No.	DATE	REVISIONS	
		DRT REVIEW AND RESPONSE	INT MDM
1	5/27/2024

VILLAGE DRIVE APARTMENTS
2955 VILLAGE DRIVE
LOT A AND LOT B
MT. OFFICE PARK
SUBDIVISION

GRADING &
DRAINAGE PLAN

LEVEL SPREADER
N.T.S.

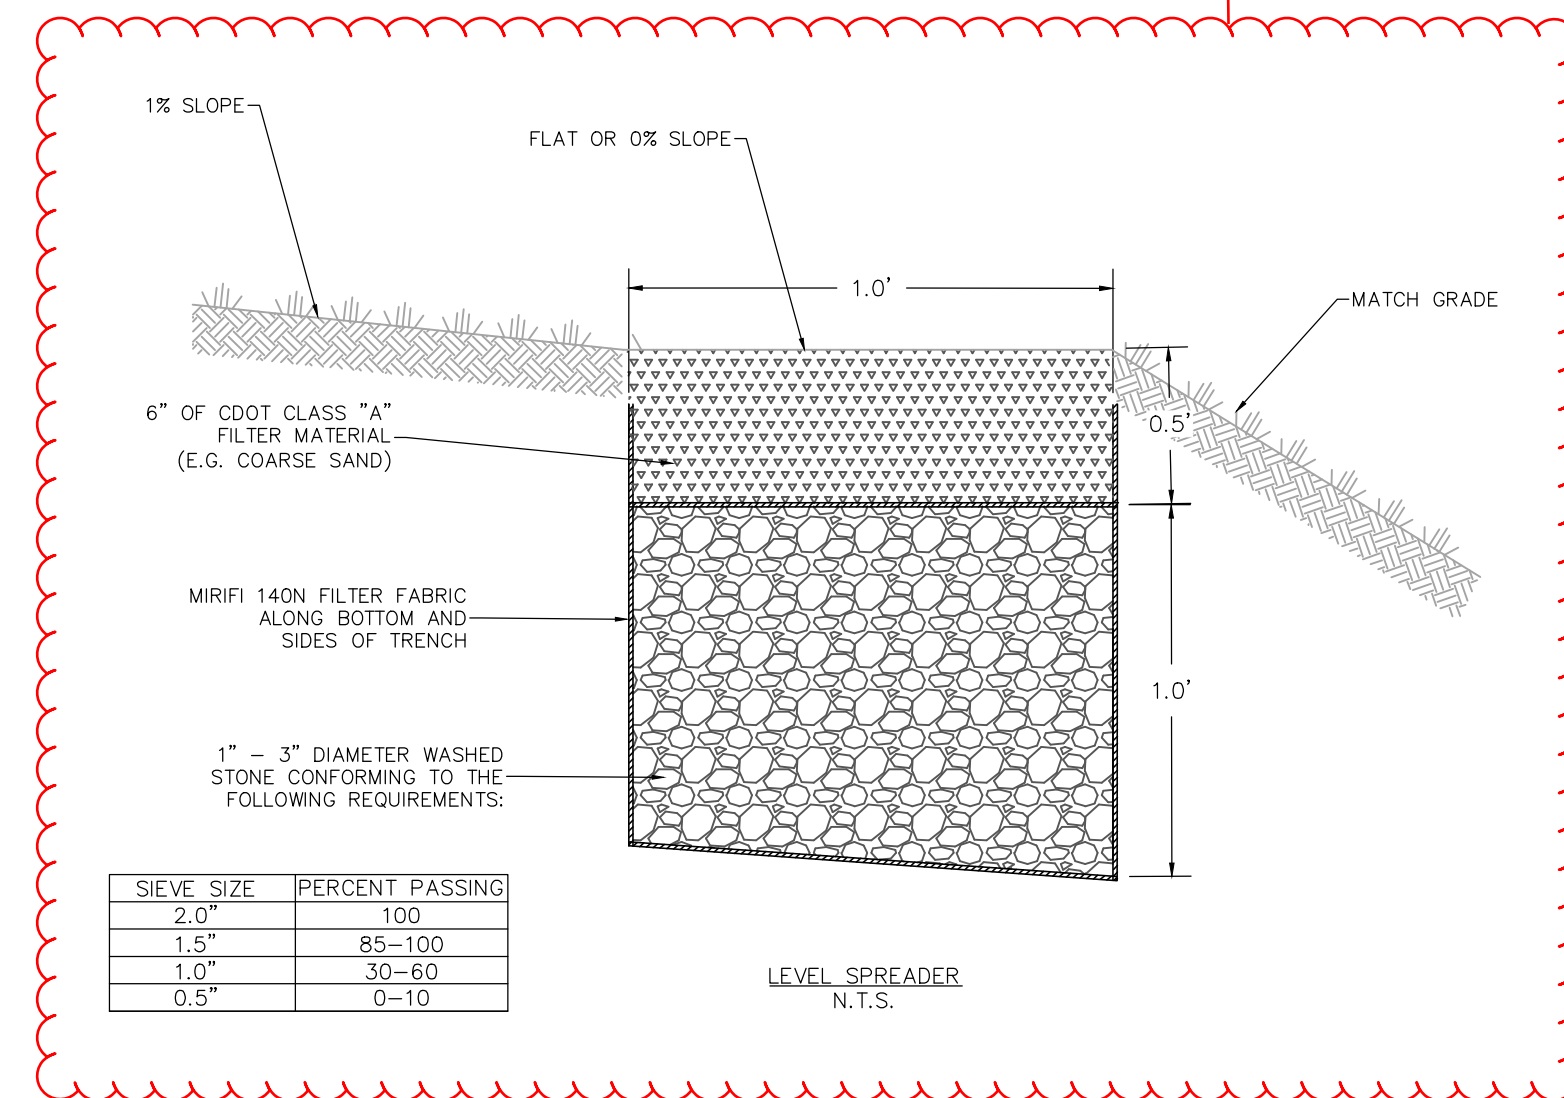
C4 Level Spreader shall be concrete or similar material that will not erode overtime.
